DFCM Addendum #3

Reference: Bastian Equestrian Arena
DFCM Project #25401770
U3P Event #CS25039-Stage II

ADDENDUM NO. 1
April 14, 2025

USU Bastian Equestrian Arena

EXTERIOR
ELEVATIONS

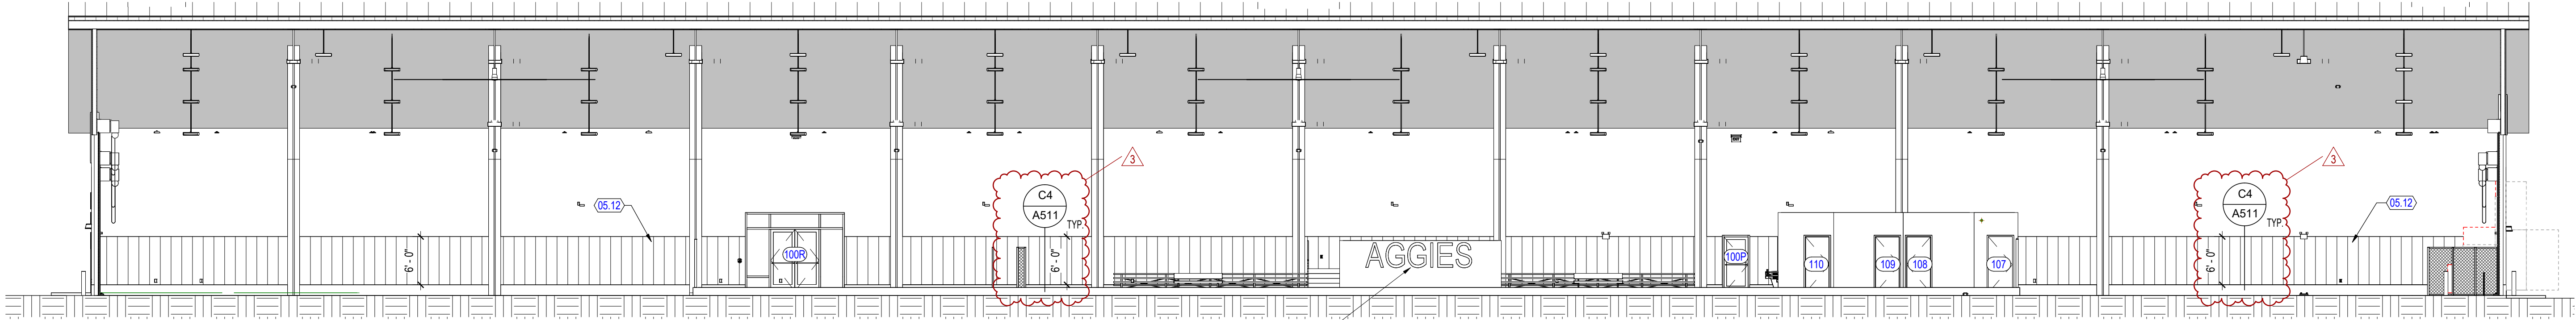
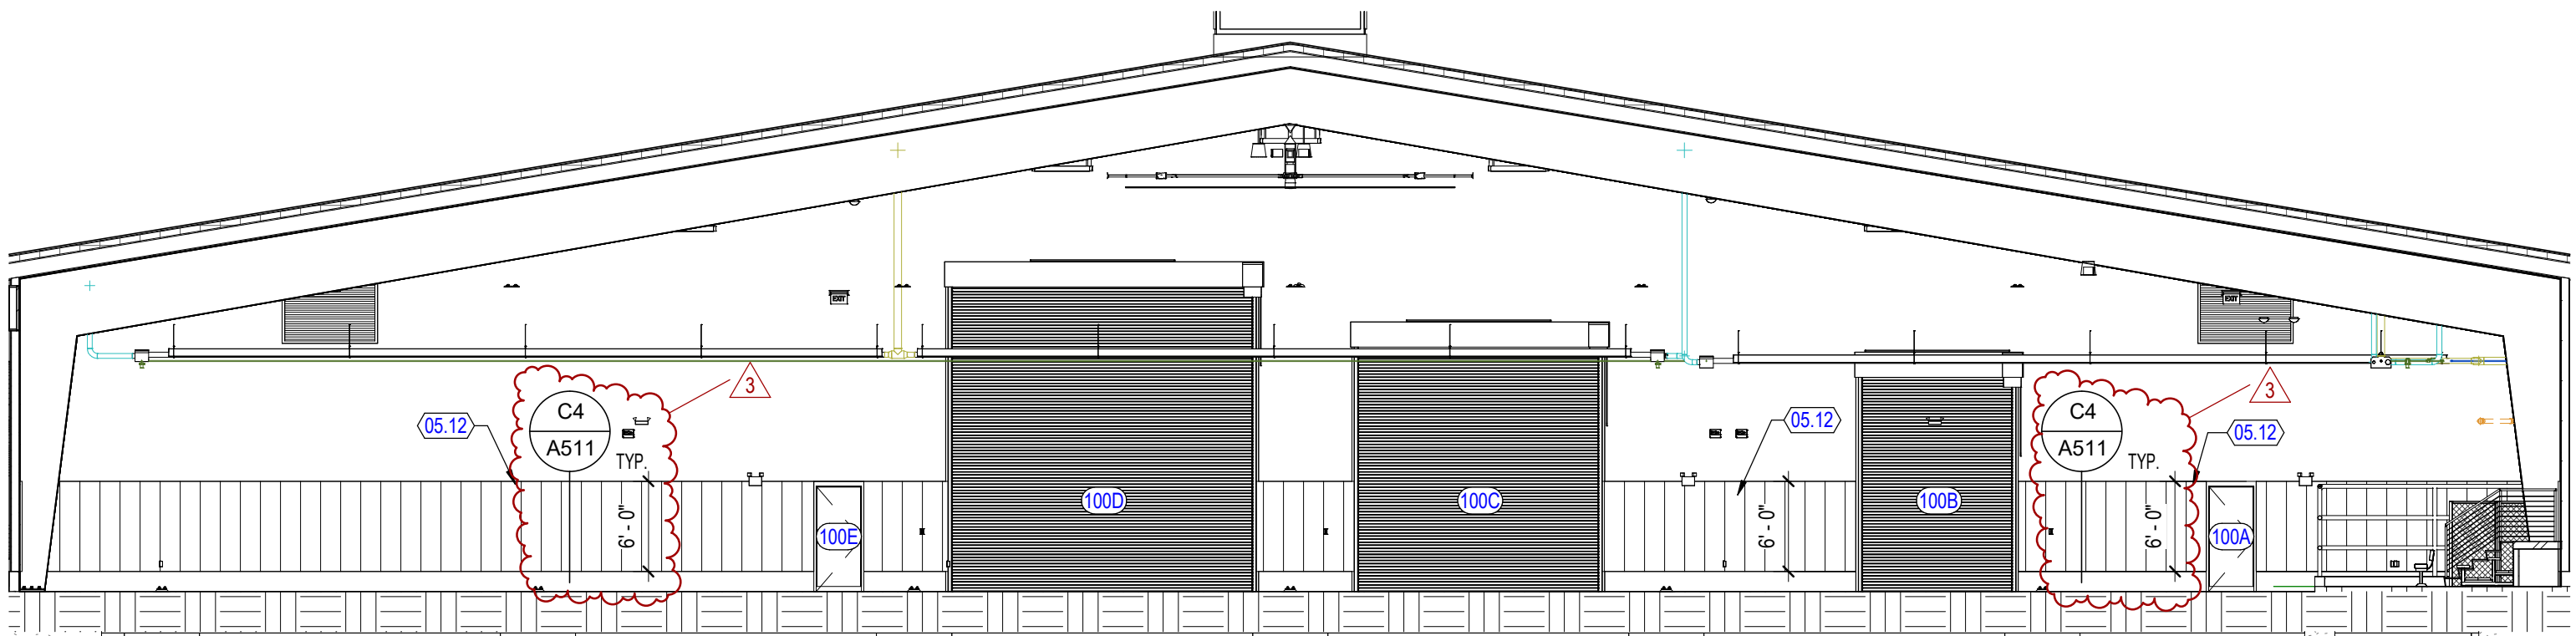
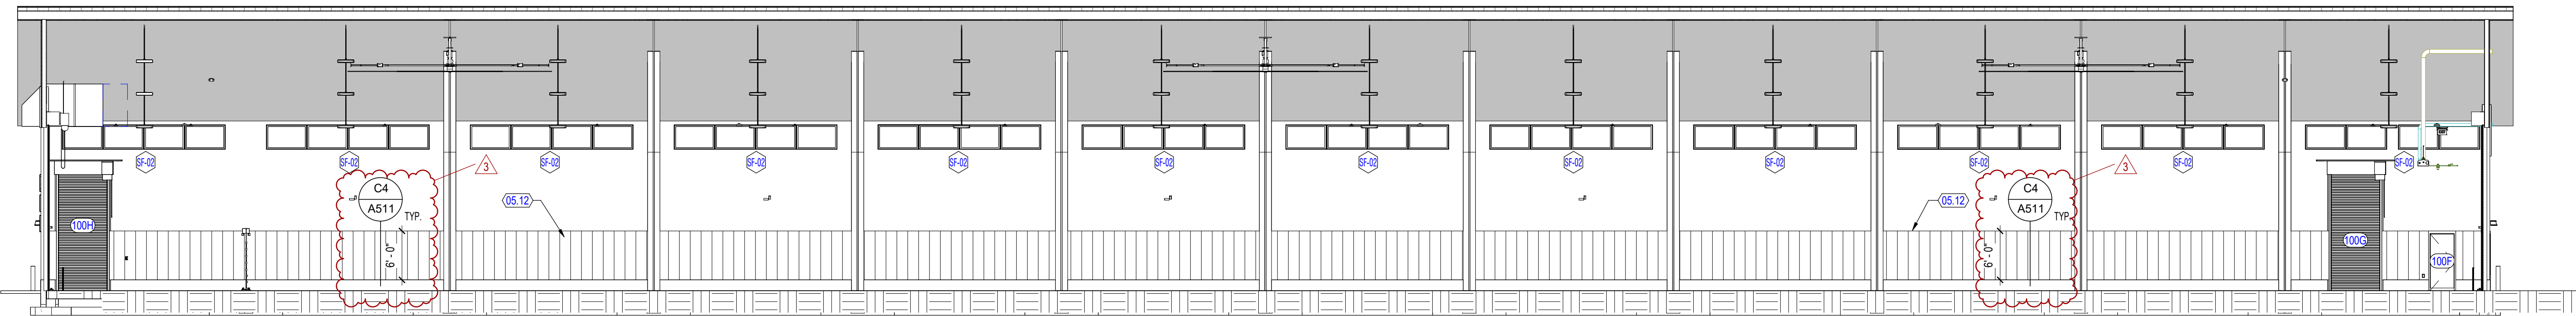
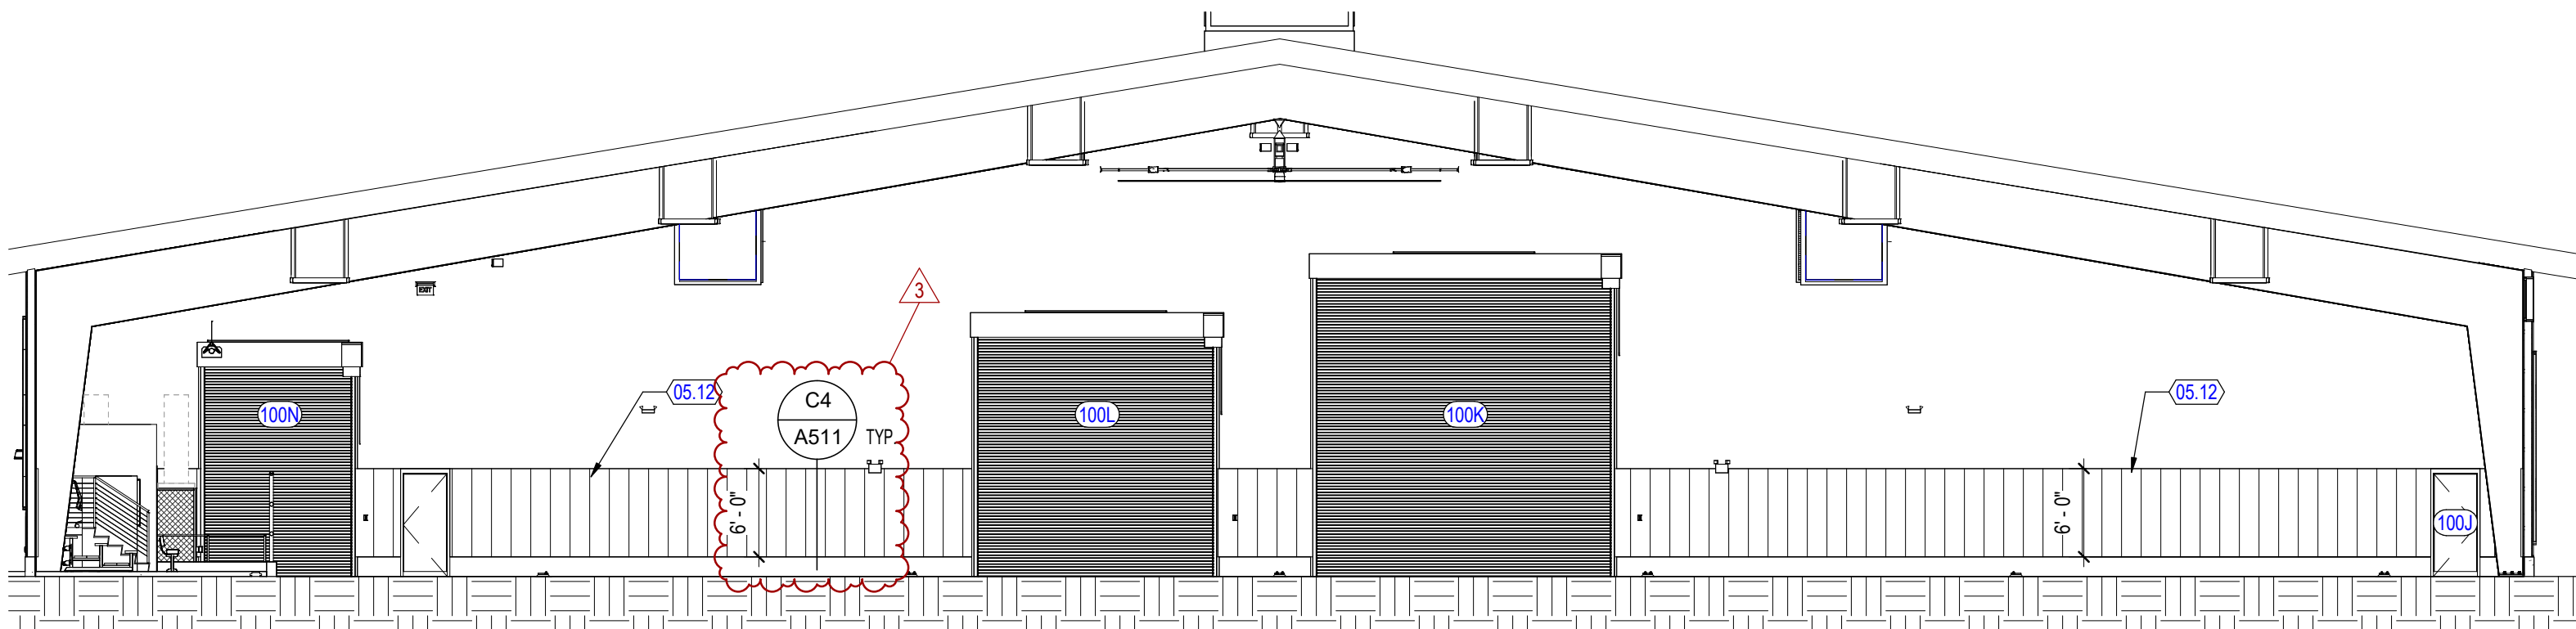
Question 007 - A202 – Do we need guttering or rain/snow protection above doors on the northeast elevation – doors 100F, 100G, & 100H?

Response: The roof plan and elevation sheets have been updated to show a gutter and snow cleats above doors 100F, 100G and 100 H.
